# FINAL PLAT SPOTSWOOD ADDITION TO SEDGWICK COUNTY, KANSAS

RE: SUB 2001-49 -- One-Step Final Plat of Spotswood Addition

RE: SUB 2001-49 -- One-Step Final Plat of Spotswood Addition

**CASE NUMBER:** SUB 2001-49 -- SPOTSWOOD ADDITION

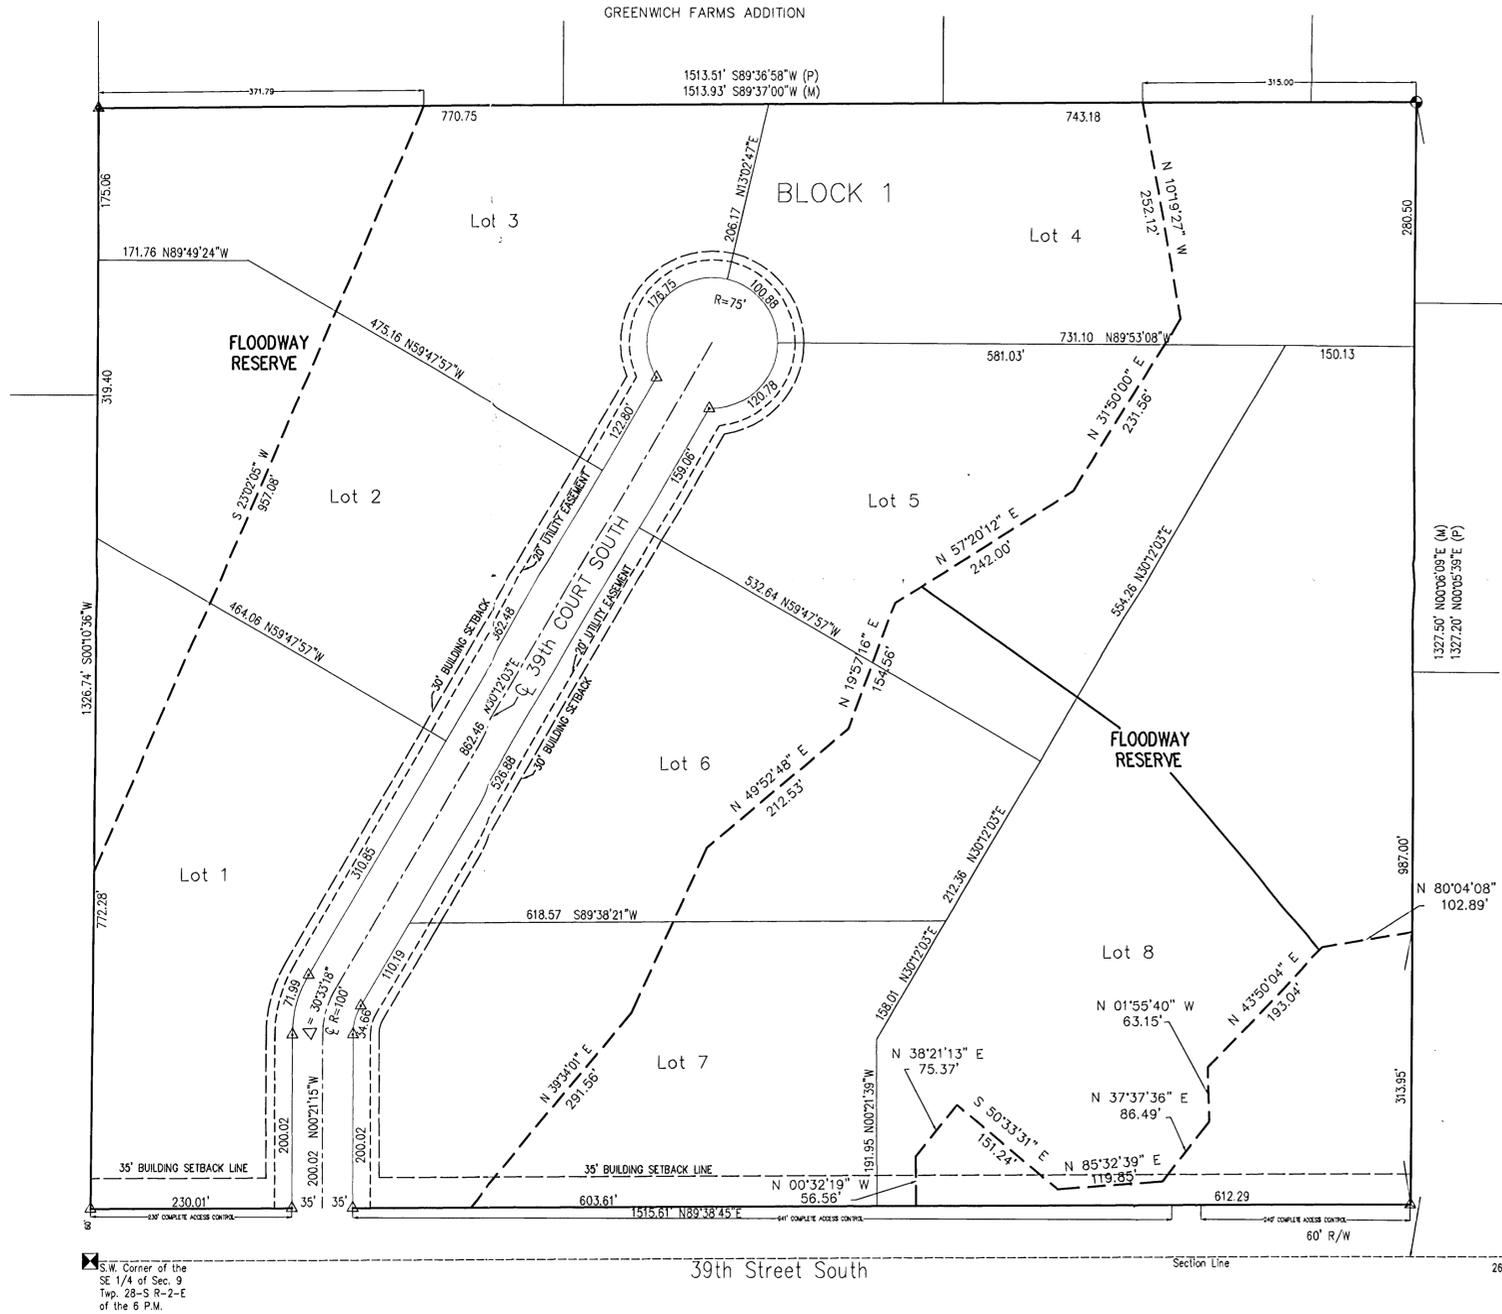
- A. Since neither municipal water nor sanitary sewer is available to serve this property, the applicant shall contact the Environmental Health Division of the Health Department to find out what tests may be necessary and what standards are to be met for approval of on-site sewerage facilities and water wells. A memorandum shall be obtained specifying approval. The applicant proposes sewage lagoons for 8 lots. Health Department should comment on floodway reserve constraints. A site layout is requested for Lot 7, Block 1. The Health Department needs to approve a site layout before the MAPC Meeting.

- D. County Engineering needs to comment on the status of the applicant's drainage plan. The drainage plan is approved. A flood study is required. A minimum pad elevation needs to be established. A drainage reserve is required between Lots 6 and 7.

- E. The plat's text shall denote the creation of the floodway reserves in addition to including the standard floodway language.
- F. The applicant shall dedicate 30 feet for street right-of-way and reference said dedication in the plat's text.

- G. The diameter of the turnaround should be increased to 150 feet to conform with Subdivision Regulations.
- H. County Engineering needs to comment on the access controls. The plat proposes one access opening along MacArthur Road for Lot 1, Block 2. One opening is approved.

- I. The plat shall be included within one block. Lot 1, Block 2 should be labeled as Lot 8.
- J. The applicant shall guarantee the installation of the proposed street to the 36-ft rock suburban street standard. County Fire Department has required that the street be installed prior to the issuance of building permits.

- M. On the final plat tracing, the MAPC signature block needs to reference "J.D. Michaelis, Acting Chair".
- N. The County Commissioners signature block needs to only reference the Chair.

- O. The applicant is advised that if platted, the building setbacks must be 35 feet along MacArthur Road to conform with the Zoning setback standard for County section line roads.

- P. Approval of this plat will require a waiver of the lot depth to width ratio for Lot 4, Block 1. The Subdivision Regulations state that the maximum depth of all residential lots shall not exceed 2.5 times the width. The Subdivision Committee has approved the modification.

- Q. The County Fire Department needs to comment on the plat's street names. County Fire Department has recommended 39th Court South.
- R. The plattor's text shall include language that a drainage plan has been developed for the plat and that all drainage easements, rights-of-way, or reserves shall remain at established grades or as modified with the approval of the applicable City or County Engineer, and unobstructed to allow for the conveyance of stormwater.
